FIFTH & UNION | RAINIER SQUARE REDEVELOPMENT  
Early Design Guidance Submittal #2

PROJECT #3017644

July 25, 2014

This document has been prepared in response to the Early Design Guidance of the Downtown Design Review Board, as published in minutes of the meeting held on June 17, 2014. In that meeting, priority design guidelines were identified along with recommendations of the Board.

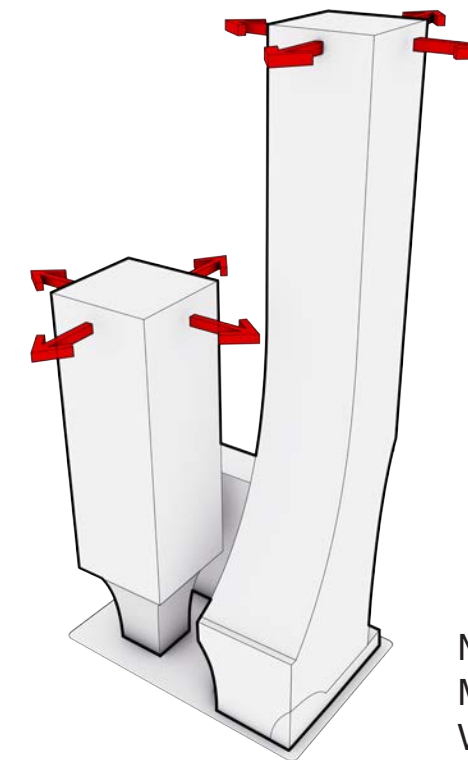
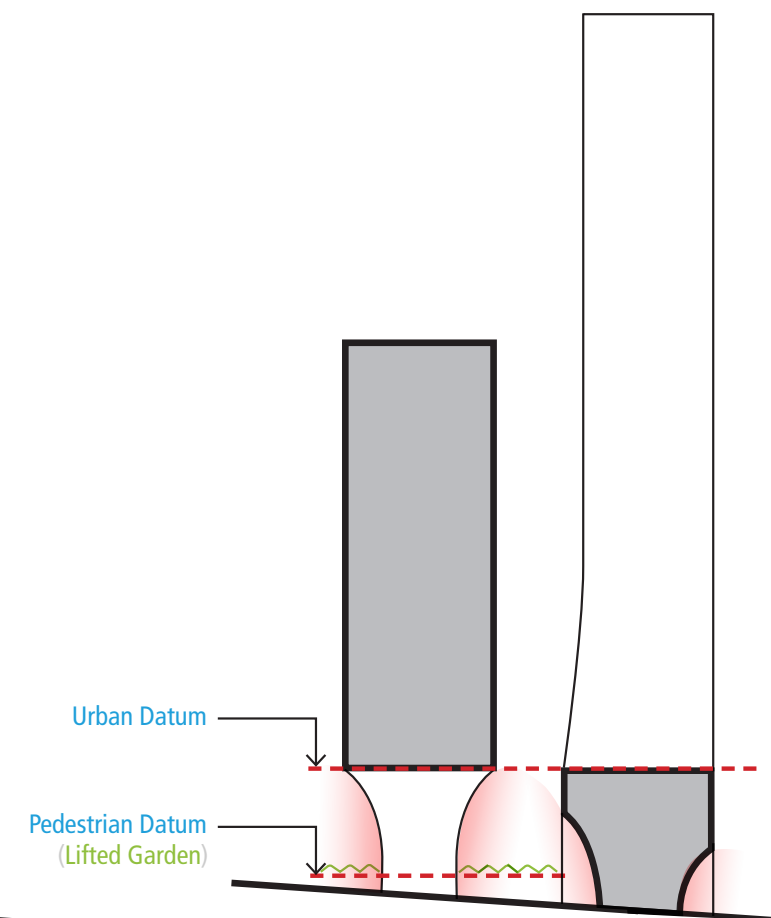
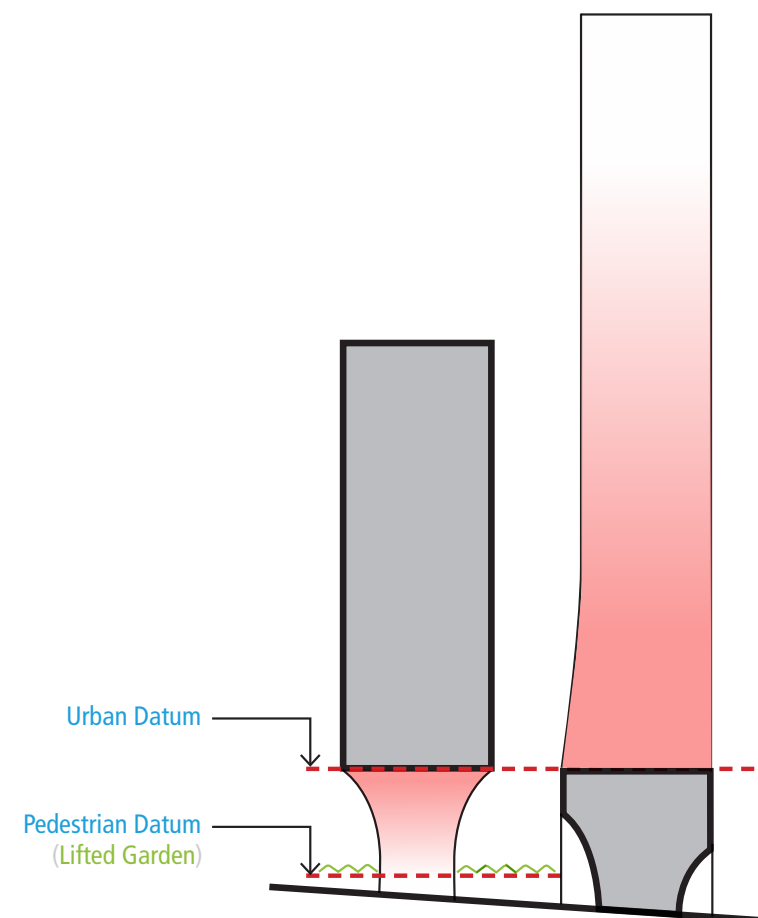
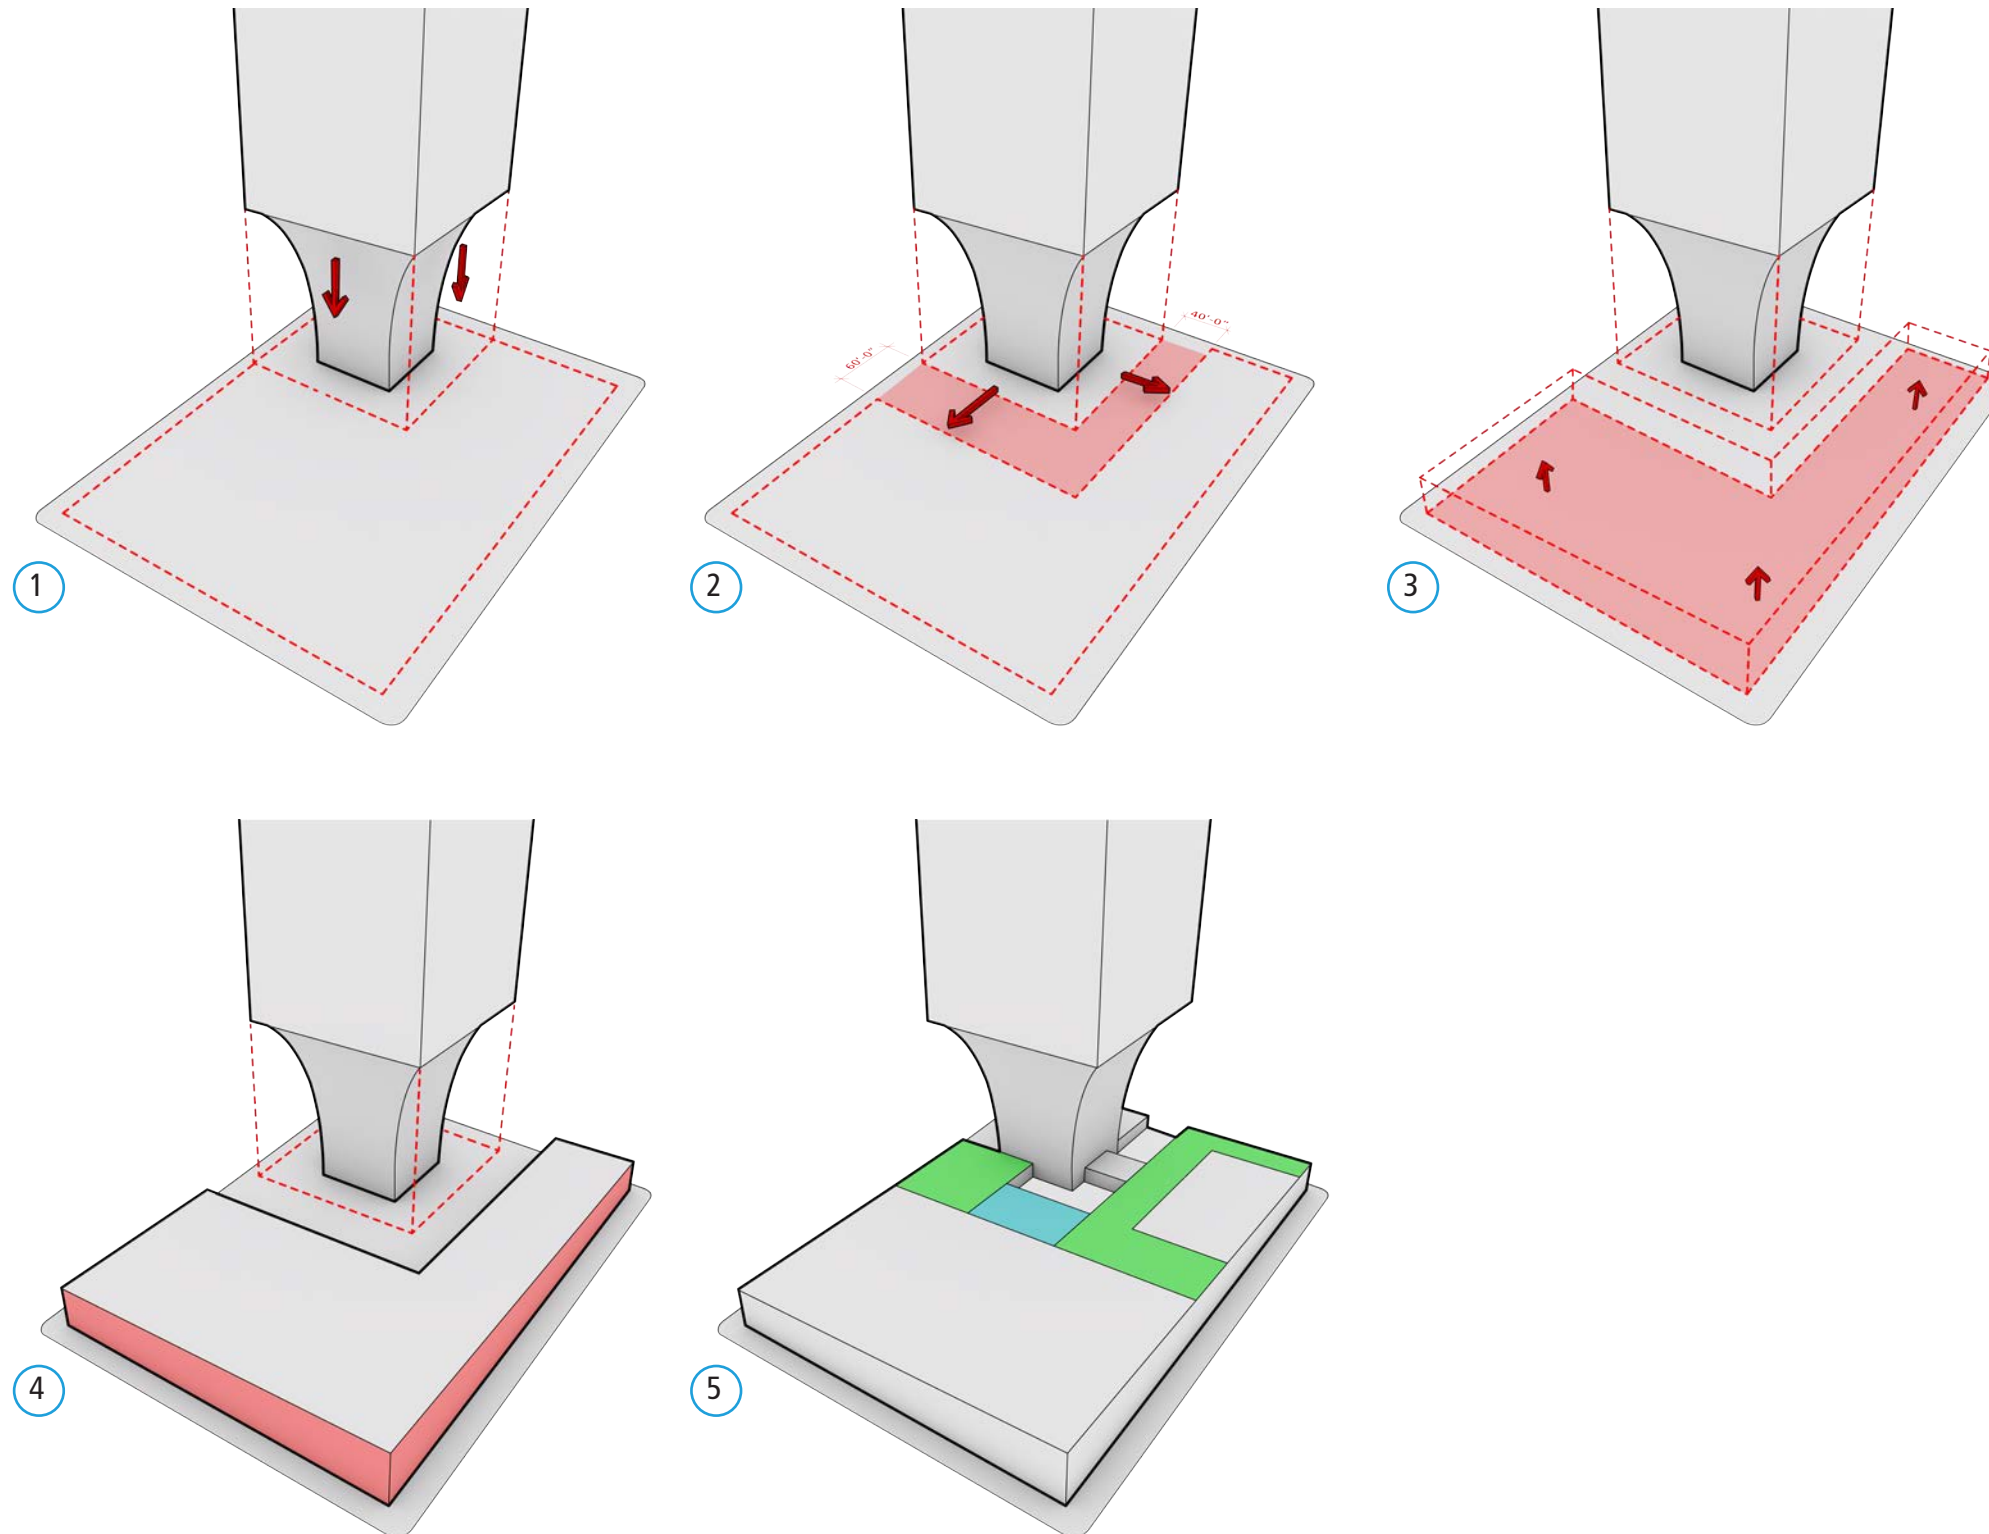
The composition of the three major massing elements (the Rainier Tower and the proposed structures) ought to appear as if communicating with one another. The additions to the block should be designed in a manner that would possess a strong relationship or "attitude" toward the tower's base. Consider a design of the new insertions into the block that would 1) express a clear spatial organization shaped by the base and the two new buildings and 2) provide sightlines to the tower's base from the north on Fifth Ave and from the west along University St. The Board noted the third scheme's reliance upon the horizontal datum line at 139 feet established by the top of the curved base in determining the beginning of the upward curve of the tower and the height of the hotel. The Board questioned the need for strictly adhering to it. The tiers of the proposed residential / office tower could commence just above the retail plinth allowing pedestrians to experience the tower's dramatic shape and opening views to Rainier Tower's curved podium.

The open space for the proposed project has been configured to provide visual relief around the base of Rainier Tower, giving it "breathing room" and providing dramatic views of the base from the surrounding streets as well as from the common interior spaces of the new development via a large glass-ceilinged atrium. The massing composition of the proposed structures builds from a common pedestrian datum, or "plinth", incorporating a variety of vibrant, pedestrian-oriented retail uses, and sets back from the existing tower base above this level to establish a volumetric urban space that is complementary to the sculpted base of the existing tower. This combination of open space and massing setbacks at the base of the development creates a "lifted urban garden" space that responds to and communicates with the unique geometry of Rainier Tower.

At the top of the existing base, an urban datum establishes an inverse and complementary relationship between the upper levels of the proposed tower to the north, the top floor of the proposed hotel to the west, and the rectangular shaft of the existing tower. As it rises from this datum, the proposed tower gradually slopes away from the existing Rainier Tower, preserving views to the north, and culminating in a slim rectangular profile at the top floors in the northwest corner of the block. In this way, the upper levels of the two towers are set in diametric positions on the block, allowing maximum light, air, and views for both of the towers as well as for the surrounding urban spaces.

The base of the proposed tower along Fifth Avenue has been articulated to fade back from the base of Rainier Tower at the lower levels to enhance sightlines from the pedestrian streetscape. Along University Street, the hotel has also been set back significantly to open up views of the existing Rainier Tower base.

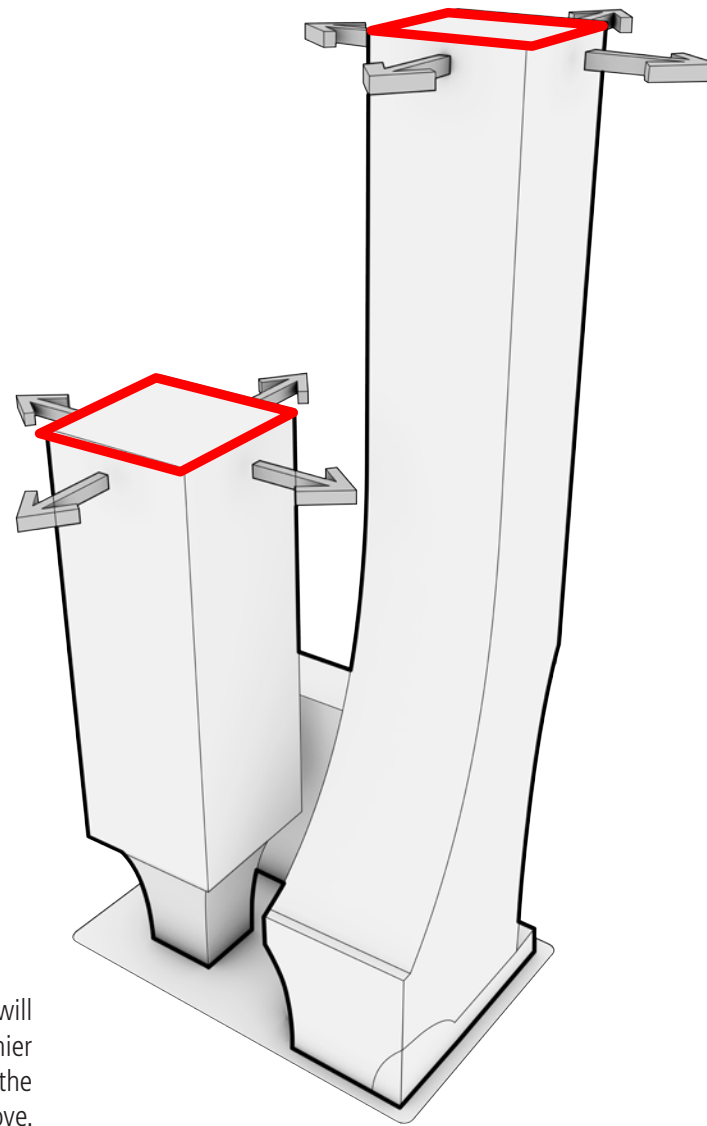
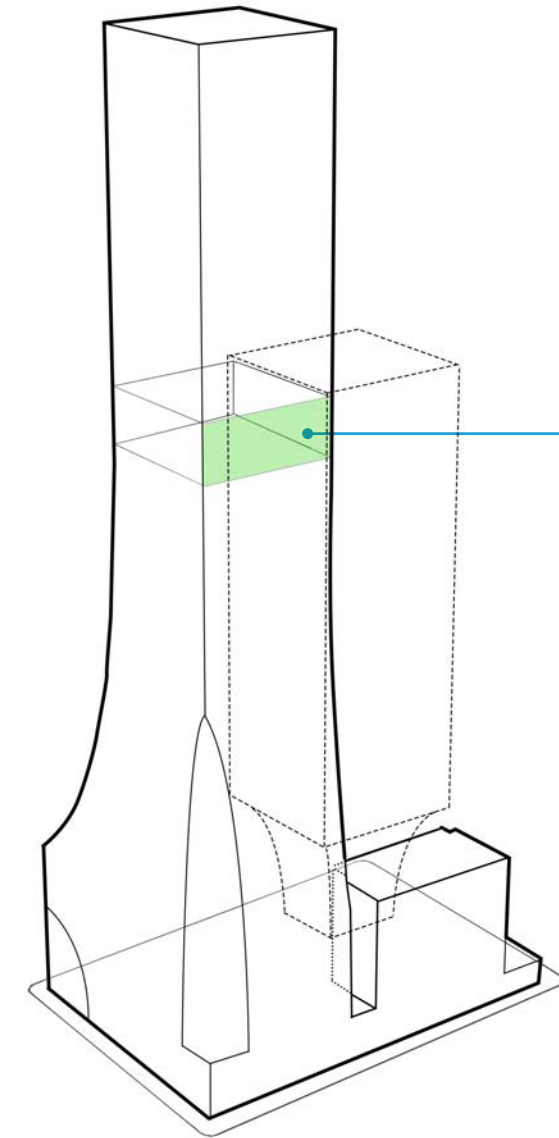
In order to achieve the guidance provided in A1 above, the Board suggested that the applicant consider building higher and consider other departures, similar to the façade modulation (request # 1 in the booklet), which may enable the lower realms of the complex to have a clearer spatial organization.

The upper reaches of the proposed tower have proportions roughly similar to Rainier Tower, square in plan, with a blunt or flat roof. While the architect conveyed the intention of relating the two towers by this similarity of form, the Board members indicated an interest in a more dramatic shape or expression on the skyline. Seattle towers over 40 floors all possess sculpted shafts and/or interestingly shaped tops.

A taller tower does not meet the applicant's development program or projected market conditions. The location of the hotel along Fourth Avenue allows potential phasing of the project (which is key to the success of the development), and provides the potential for a distinct architectural identity. In this way it becomes an important element in the urban composition for this block. See response to A-1 above for additional discussion of the base levels of the development and sightlines to the existing Rainier Tower base.

In addition to the gradual reduction in floor plate size as the tower ascends, the top of the tower will possess a unique and distinct identity, expressed through a palette of materials and detailing at the upper levels to form a distinct "top" or "cuff". Its height will provide a visual landmark for downtown on the skyline, adding to its visual interest and variety.

A similar expression at the top will complement Yamasaki's Rainier Tower by not competing with the simple and elegant formal move.
